**Request for Agency Comments  
City of Woodinville**

FILE NO.: PPA13002/SEP13019

PROJECT NAME: Brickyard Ridge Subdivision

PROJECT DESCRIPTION: Preliminary plat application to subdivide an existing 4.13 acre property consisting of four (4) legal parcels into thirteen (13) single-family residential lots in the R-1 and R-6 zoning districts. Construction will include grading, erosion control, street frontage, tree protection, and drainage improvements. SEPA is required for developments of five or more lots.

FIGURE D103.1  
DEAD-END FIRE APPARATUS ACCESS ROAD TURNAROUND

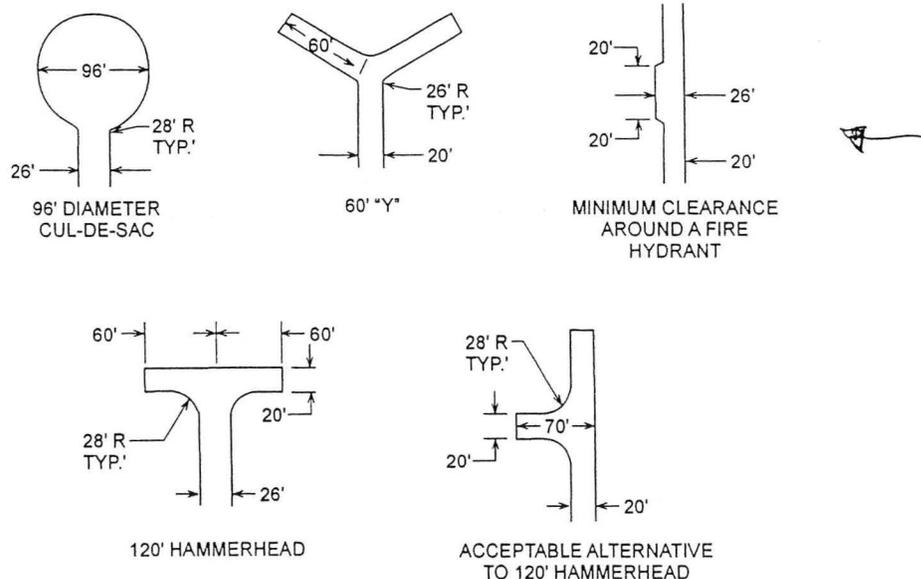
7. Plans show an existing gravel driveway, which we were told does not exist in letters from the owner and surveyor.
8. The hammerheads should be dimensioned and must meet the 2009 International Fire Code Requirements (See Attached).
9. Please submit calculation with the final construction plans for the Gravity Block Wall and Rockeries if they are over 4-ft high.
10. All easements must be shown in the proposed plans.
11. Traffic report must be revised to show both the existing and proposed, Level of Service for the left hand turn out onto NE Woodinville Duvall Road from 151<sup>st</sup> for both the AM & PM time periods. The traffic impact fees should also be revised to include the 2014 increases.

LENGTH (feet)	WIDTH (feet)	TURNAROUNDS REQUIRED
0-150	20	None required
151-500	20	120-foot Hammerhead, 60-foot "Y" or 96-foot-diameter cul-de-sac in accordance with Figure D103.1
501-750	26	120-foot Hammerhead, 60-foot "Y" or 96-foot-diameter cul-de-sac in accordance with Figure D103.1
Over 750		Special approval required
